P 515996 - C

A REPAIR

ON-SITE SEWAGE DISPOSAL SYSTEM HOWARD COUNTY HEALTH DEPARTMENT BUREAU OF ENVIRONMENTAL HEALTH

ADDRESS: 12620 Route 108 PROPERTY OWNER: Kirit Parmar

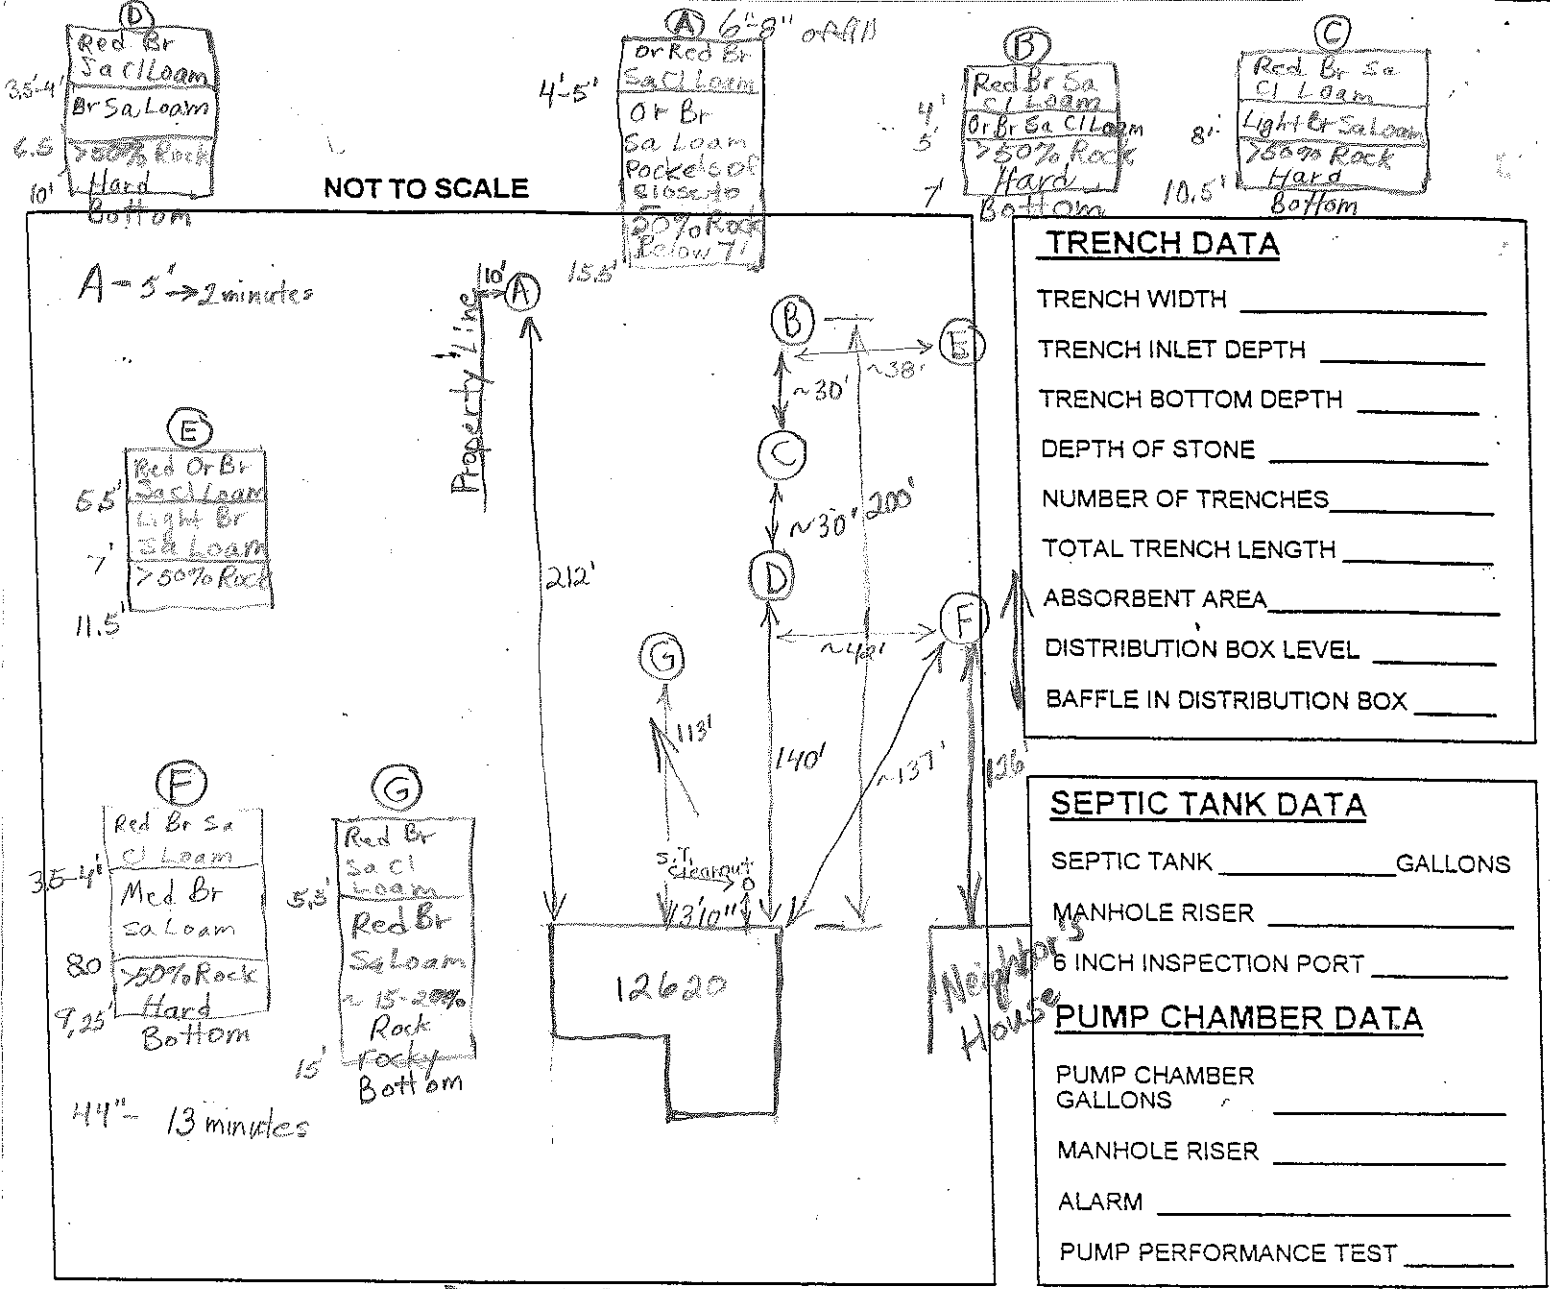
TRENCHES:	Trench to be _____ feet wide. Inlet _____ feet below original grade. Bottom maximum depth _____ feet below original grade. Effective area begins at _____ feet below original grade. _____ feet of stone below distribution pipe.
LOCATION:	
PURPOSE:	To replace septic tank. Call for inspection when ground is opened so sanitarian can recommend repair.

INSPECTION COMMENTS: 8/28/11 Encountered rocky soil conditions toward rear of lots 1 and neighboring lot 2. Mr. Parmar asked if he could use part of lot 2 as an easement for his house. Even if maximum area available on both lots were used, repair area would be severely compromised for both lots. Suggest against building permit approval. **BB**
